Solution

Title (customer effect) REQUEST REGEN Button Missing From EATS Status and DPF Status Screens In Instrument Cluster (IC) - Chassis Equipped With New (Updated) Cluster Design - **Model Year 2018 And Newer**

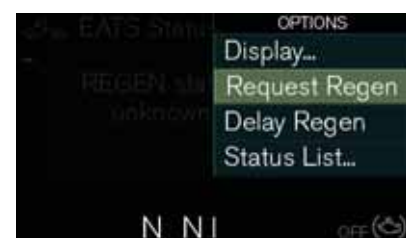
Solution An update to the Instrument Cluster software changed the location of the option to request a Parked Regeneration in the Aftertreatment screens in the driver display on units equipped with new style (color display) clusters.

Previously, the REQUEST REGEN button was located at the bottom of the screen on both the EATS Status and DPF Status menus as shown below:

Following the update, the option to request a Parked Regen is no longer present directly on the Status screens:

Request Regen is now included in the OPTIONS menu off of each of these screens as seen below. The function can only be selected if a parked regeneration is required, and is locked out if the unit is not stationary.
